HATCH INCORPORATED

DOCKET NO. 99901022/85-01

Reference is made to your letter, Docket Number as above, dated November 13, 1985 pertaining to your inspection of Hatch Incorporated (HI), results of which are recorded on Appendix A to referenced letter.

Hatch Incorporated responses to the nonconformances are listed below:

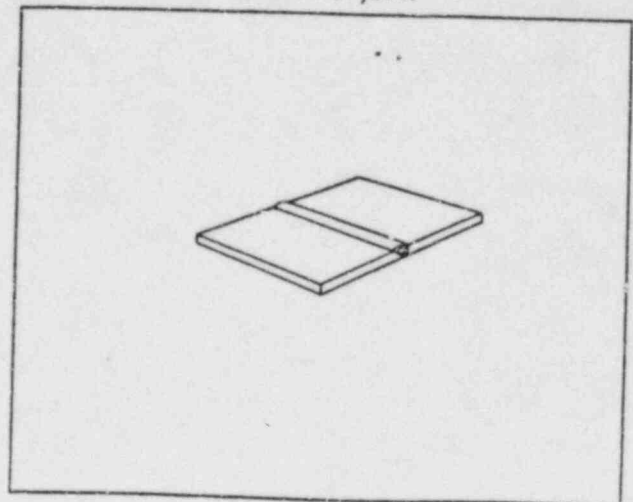
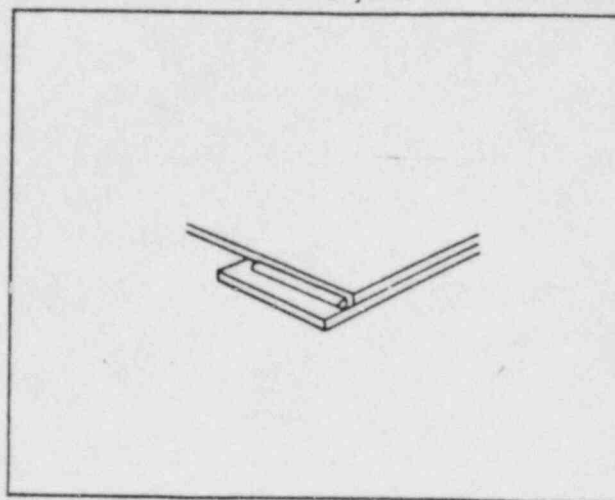
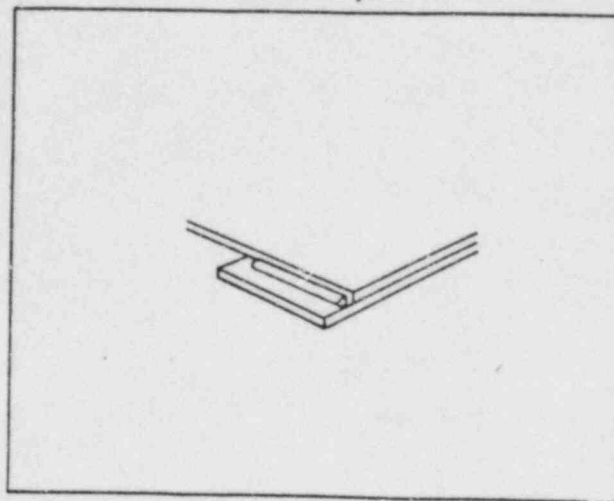
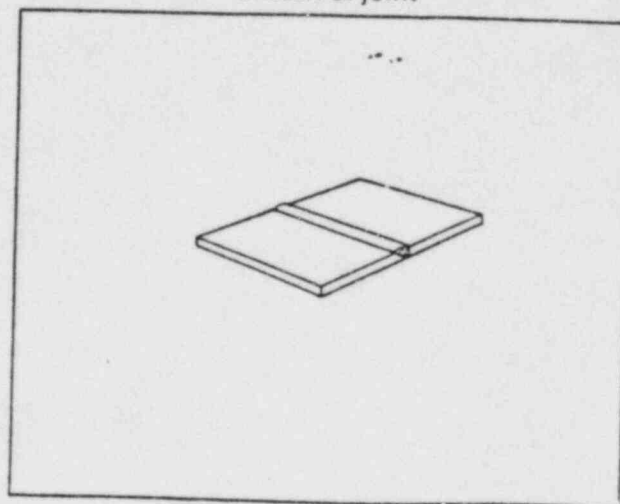
- a. (NRC) Weld Procedure Specifications (WPSs) No. 1 and 2 were qualified to AWS D1.1 (which addresses welding of base metals greater than 0.125 inches) to weld 10-14 gauge sheet metal (thickness less than 0.125 inch) instead of AWS D-1.3 which is pertinent to welding base metals less than 0.125 inch thick.

(HI) Hatch Inc. has now qualified welding procedures for base metals less than 0.125 under provisions of AWS D-1.3. Attached as enclosures are procedures 12, 13, 14 and 15 verifying this action.

Procedure no. PROC-5 Manufacturer or contractor HATCH INC.

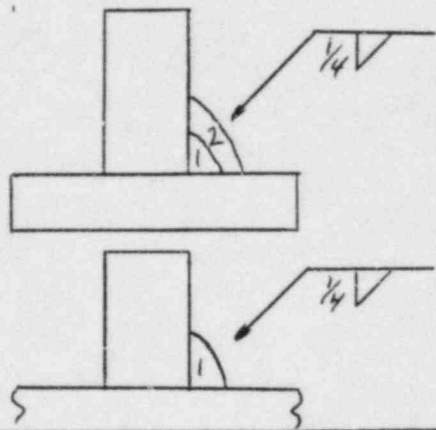
- b. (NRC) For Gas Metal Arc Welding process, AWS D-1.1 specifies that the maximum thickness permitted to be welded is that which is qualified by the Weld Procedure Specification. Contrary to this specification, WPS's No. 3, 4 and 5 have been approved without specifying the weld thickness.

(HI) Welding procedures 3, 4 and 5 have been revised to reflect maximum weld thickness permitted.
